HP07T SERIES RENEWAL

RENEWAL CONTENTS

STRUCTURE

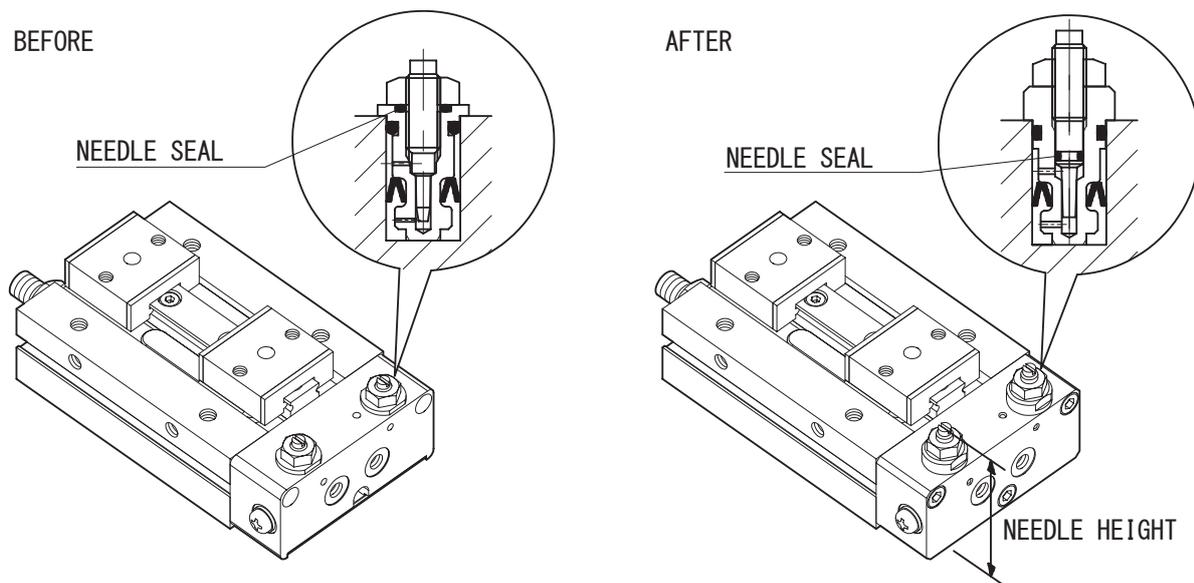
Timing Adjustment Mechanism was improved by changing position of needle seal, and needle form.
 (※ Needle Height is 3mm longer than conventional product.)
